Access Compliance Report Public Rights-of-Way (Curb Ramps)

Main Street: THIRD_RD Cross Street: MERCANTILE_WAY Location: N

ADA ID: RPRK211027171442 Ramp Type: Type 4 - Parallel Initial Pass/Fail: Fail Overall Compliance: No Severity Score: 15

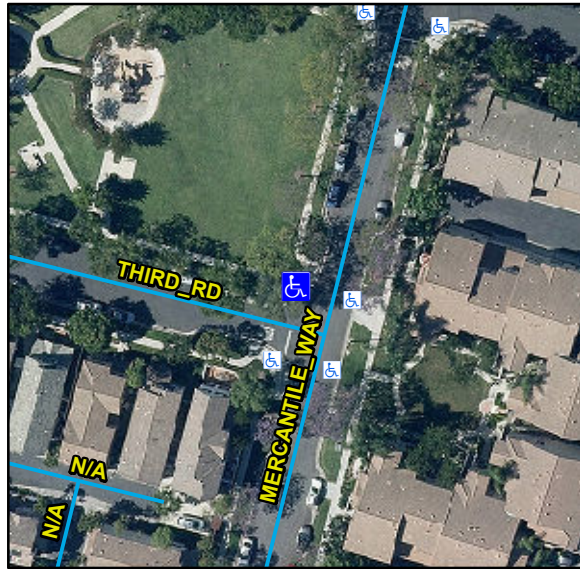
R204.3, R304.3.2, STD 1115

Compliance	Description	Data	Compliance	Description	Data
N/A	Ramp Length LT (in)	116	N/A	Ramp Length RT (in)	107
Yes	Ramp Width LT (in)	89	Yes	Ramp Width RT (in)	90
Yes	Ramp Run Slope LT (%)	6.9	No	Ramp Run Slope RT (%)	10.4
Yes	Ramp Cross Slope LT (%)	1.8	Yes	Ramp Cross Slope RT (%)	0.6
N/A	Landing Present	N/A	N/A	DWS Provided	N/A
N/A	Landing Length (in)	N/A	N/A	DWS Contrast	N/A
N/A	Landing Width (in)	N/A	N/A	DWS Length (in)	N/A
N/A	Landing Run Slope (%)	N/A	N/A	DWS Full Width	N/A
N/A	Landing Cross Slope (%)	N/A		DWS Offset Type	N/A
N/A	Landing Movement Obstructed?	N/A	N/A	DWS Offset Left (in)	N/A
	Landing Movement Type	N/A	N/A	DWS Offset Right (in)	N/A
N/A	Landing Shared	N/A			
N/A	Clear Space	Yes			
N/A	Clear Space To Crosswalk (in)	N/A			
N/A	Marked Crosswalk 1	No	N/A	Marked Crosswalk 2	No
	Crossing 1 Direction	SW		Crossing 2 Direction	SE
	Marked Crosswalk 1 Width (in)	N/A		Marked Crosswalk 2 Width (in)	N/A

Remove & Replace Curb Ramp With Two New Directional Ramps or Equivalent.
